Date: January 11, 2016

NOTICE TO ALL BIDDERS

- 1.16 CORRECTION: Update detail 2/A3.0 with the attached 1/A3.0-SK-1
- 1.17 CORRECTION: Replace sheets A4.0, A5.0, A7.1 with the attached corresponding sheets

Project Name: CITY OF EDINBURG. FIRE STATION #5

A8.0-SK1

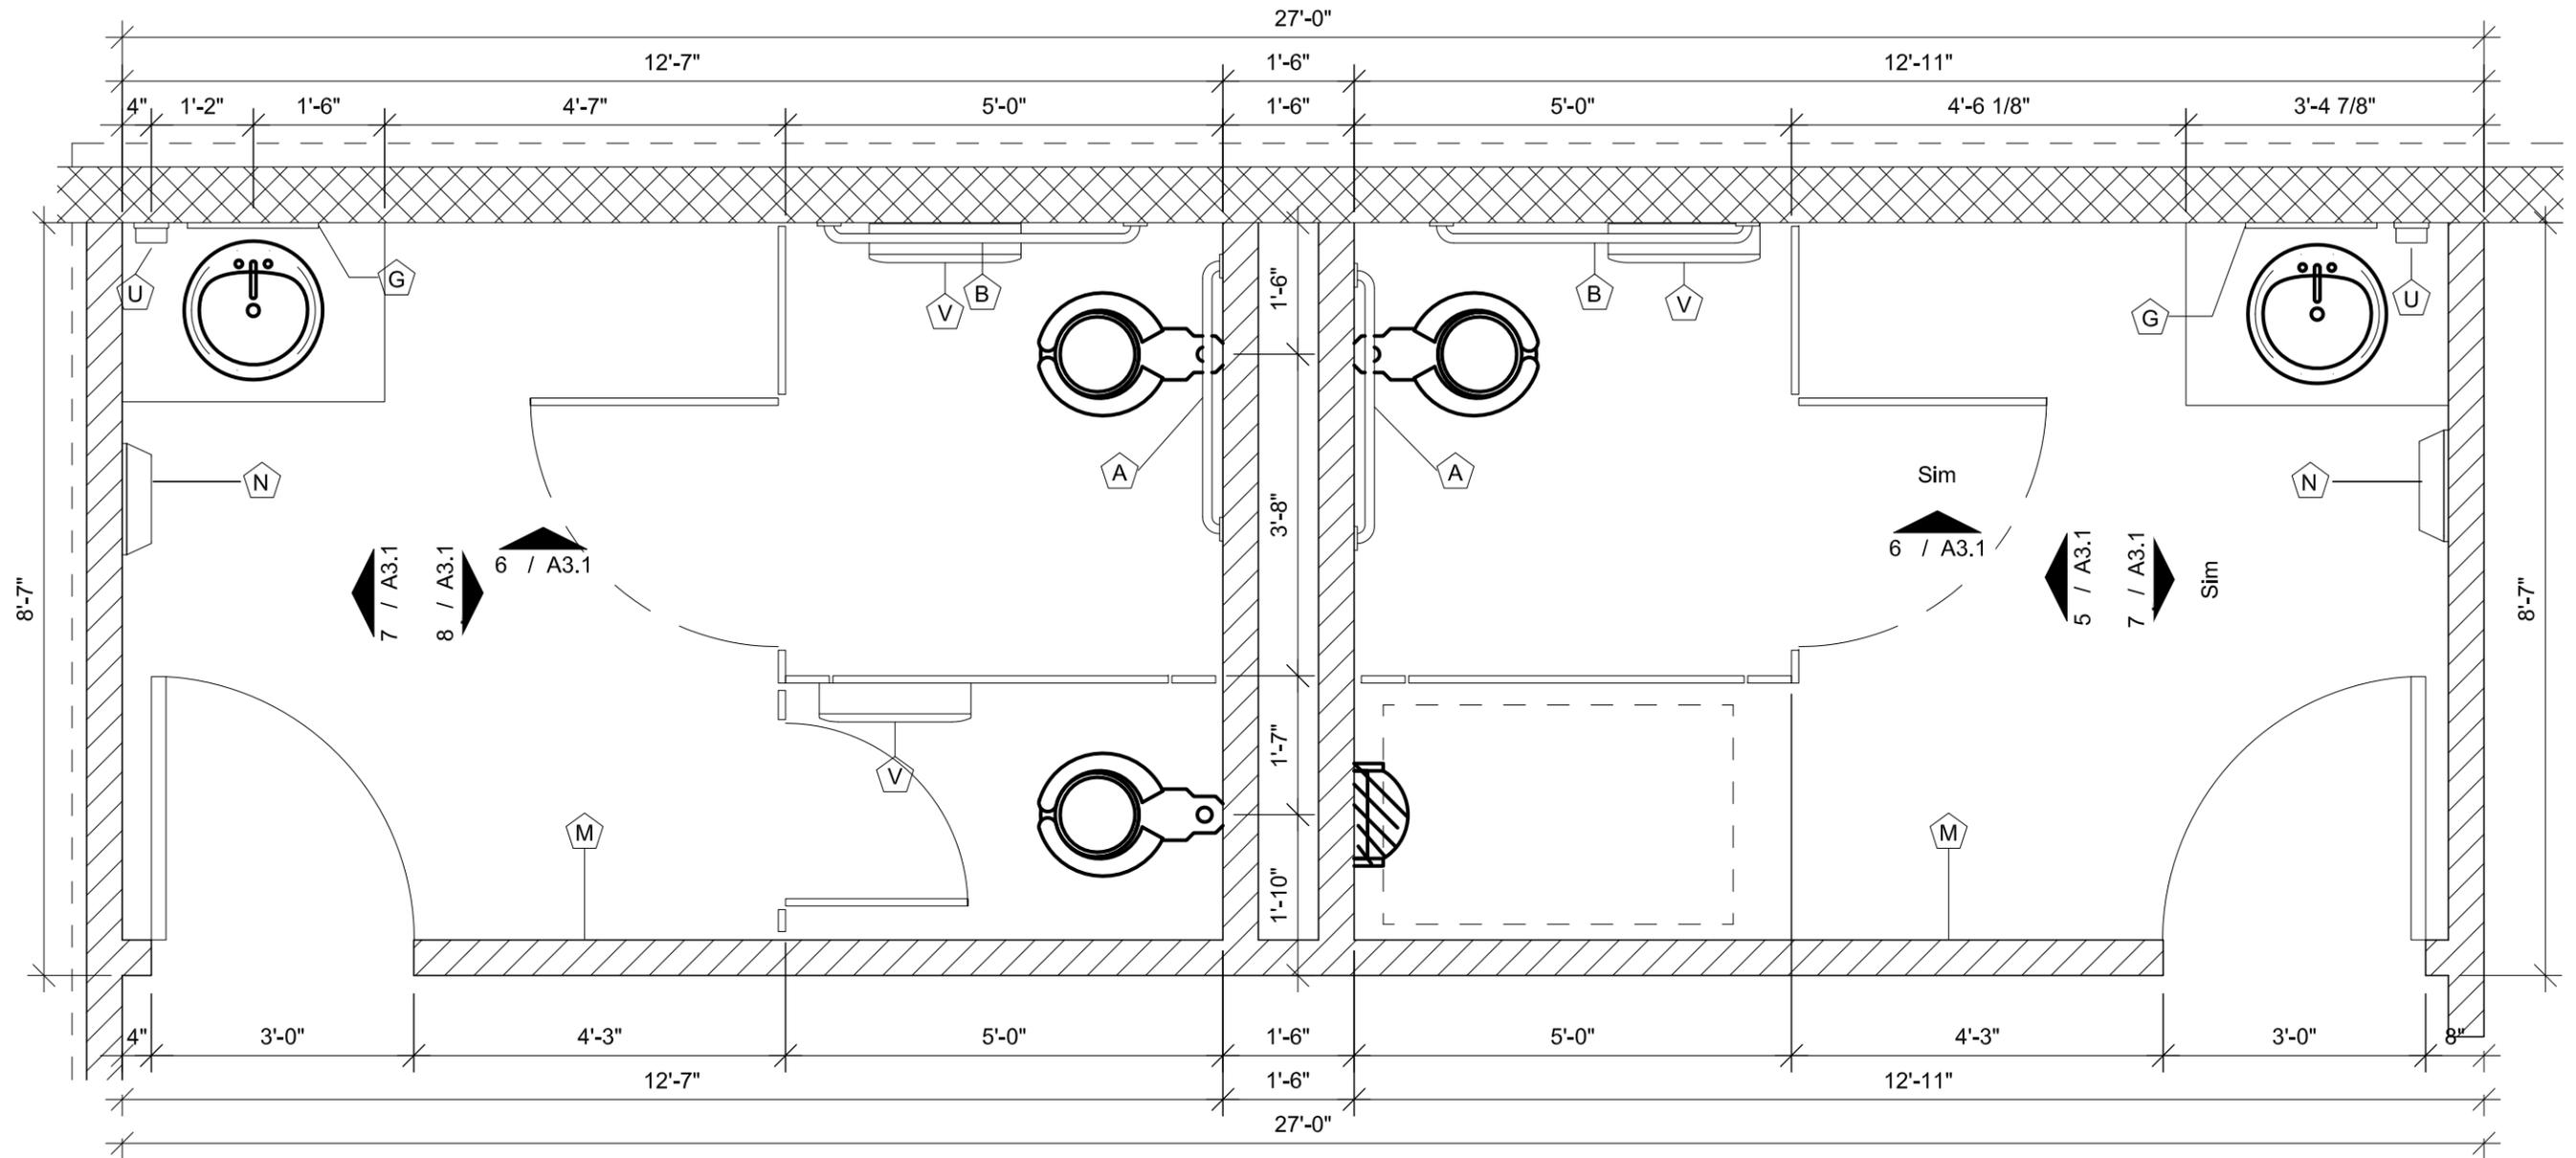
- 1.01 Refer to detail 1/A8.0-SK1 for proposed building plaque layout.
- 1.02 For Wire shelf at Laundry room 118, please use ClosetMaid white with adjustable mount wire shelving or equal

A4.0

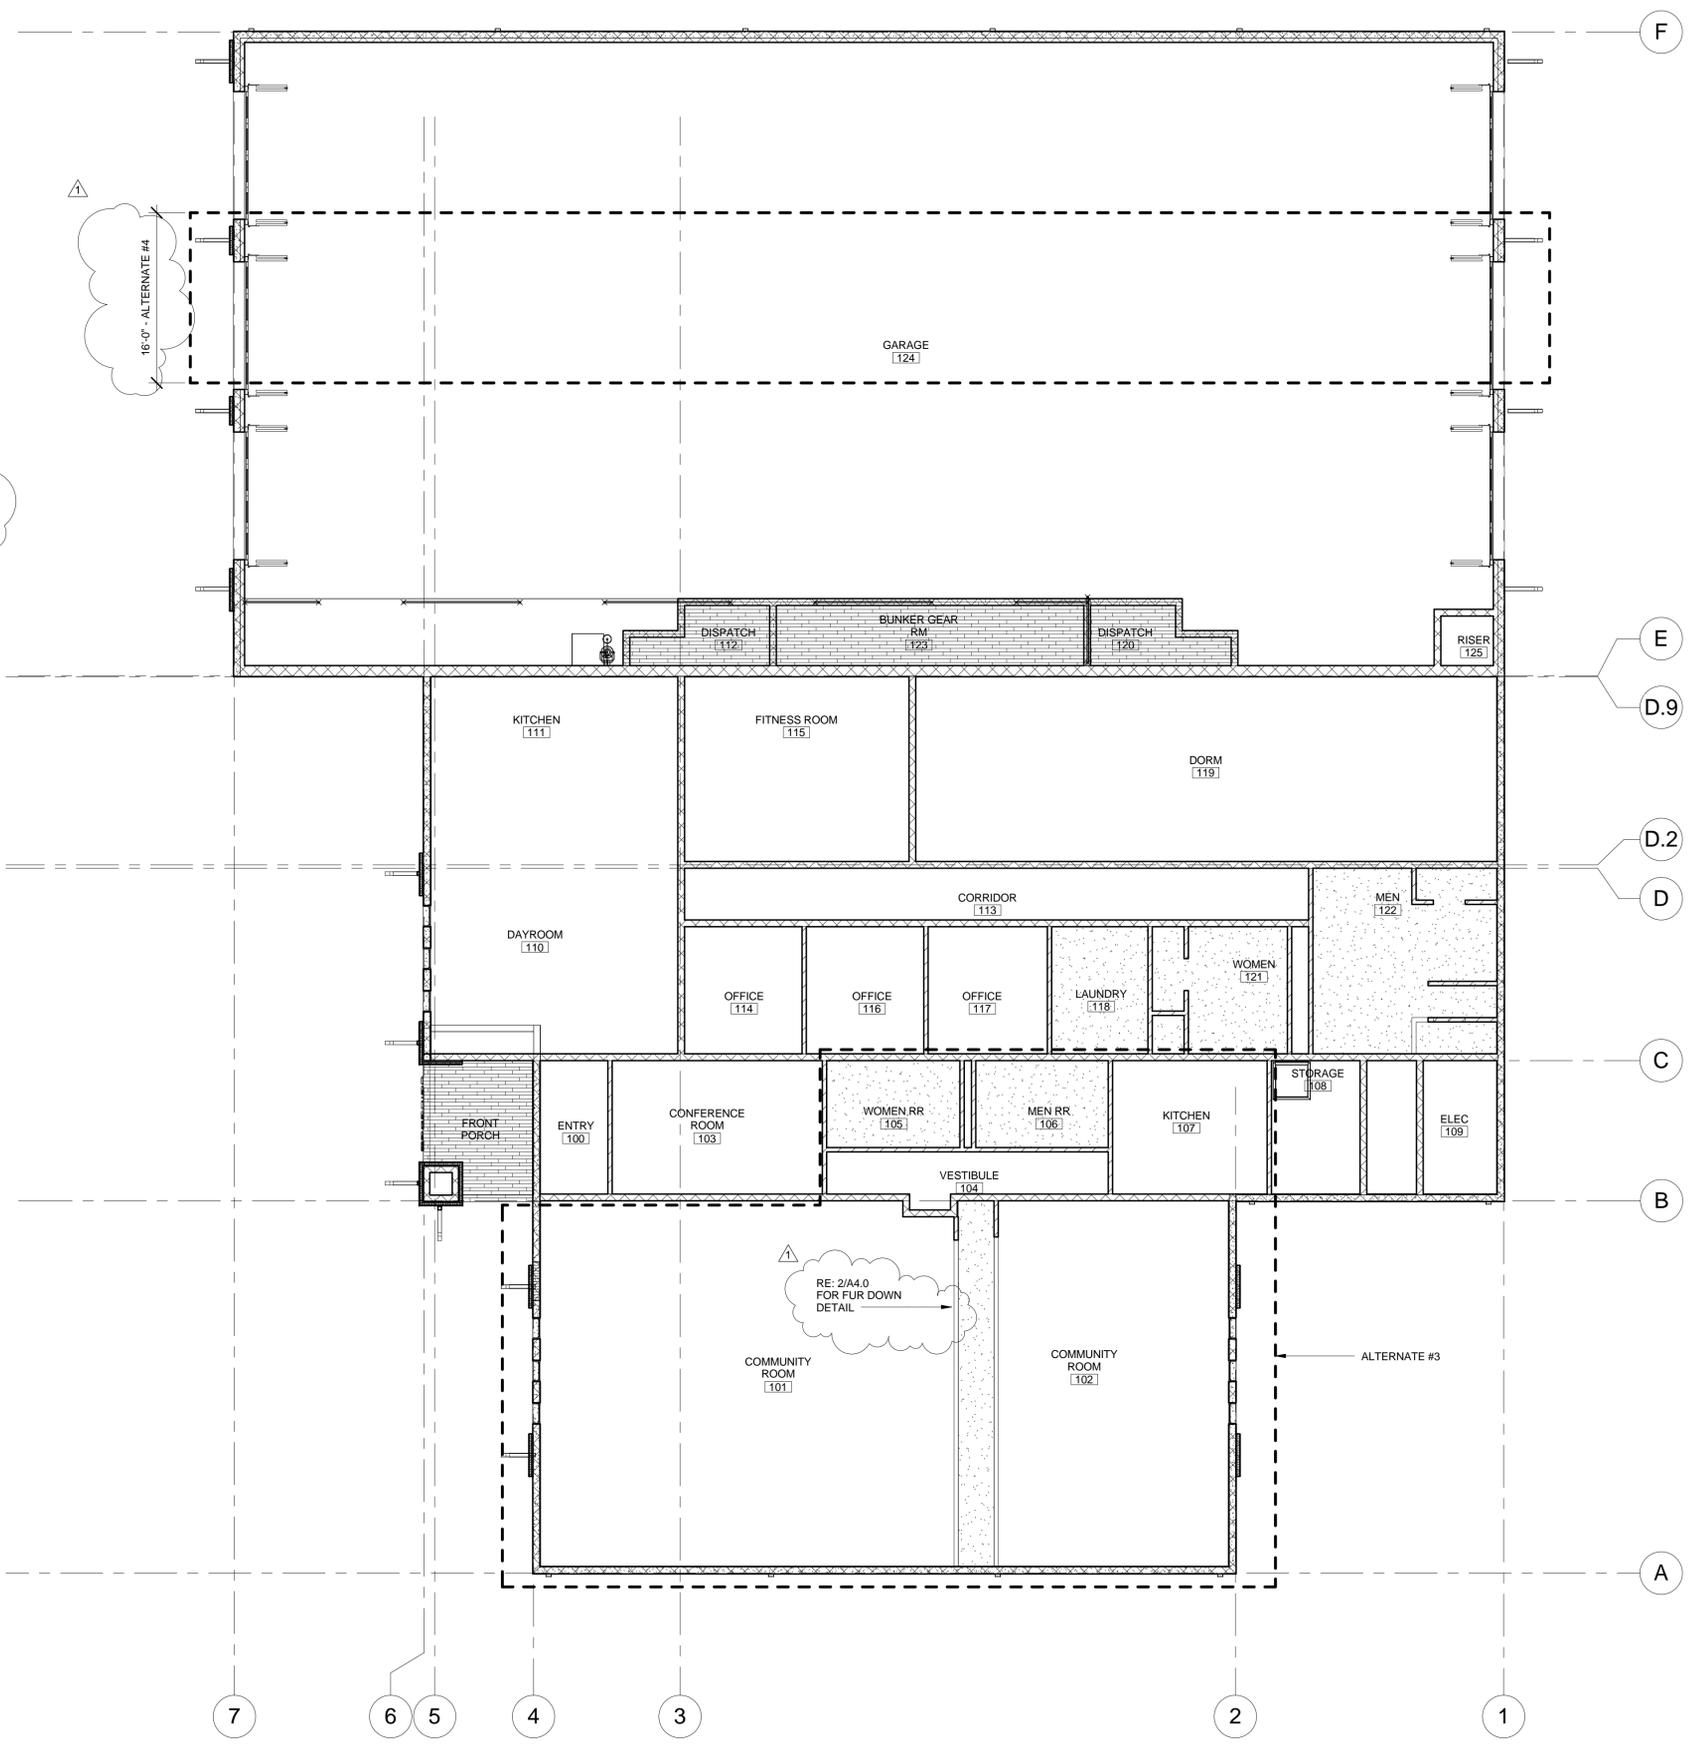
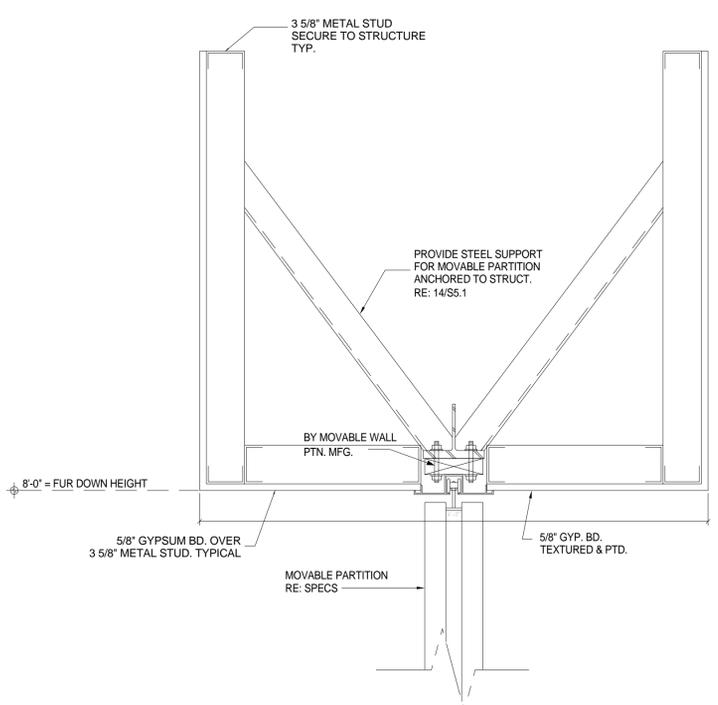
- 1.08 CLARIFICATION: Provide and install fourteen (14) wall mounted Red Ready Racks 24” Wide.
- 1.09 CLARIFICATION: Materials listed in sheet A4.0 pertain to ceiling finishes only

C2

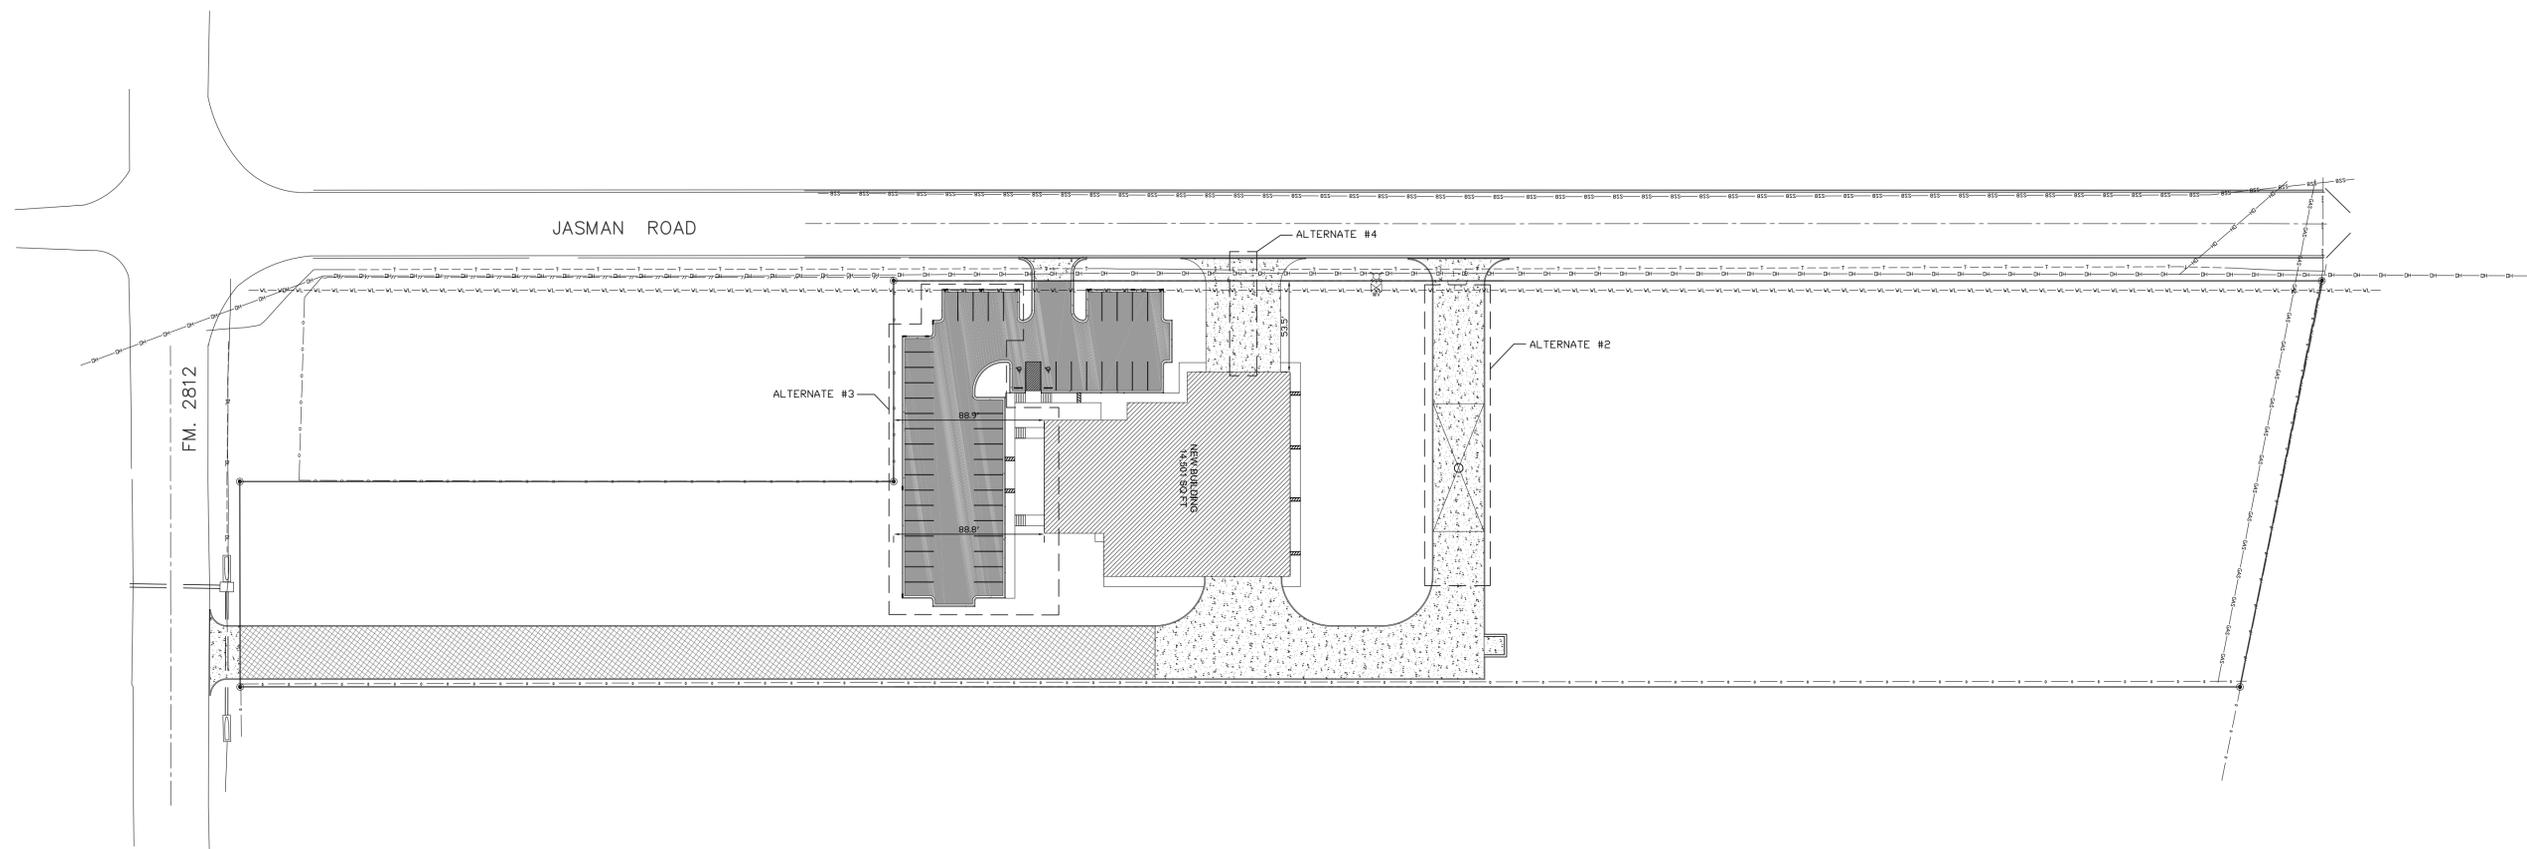
1. **C2** – Replace sheet C2 dated 9-16-15 with attached sheet C2 dated 1-07-16.
2. **C2A** – Add Sheet C2A “Proposed Site Plan Layout – Alternates” to the Contract documents. See attached.
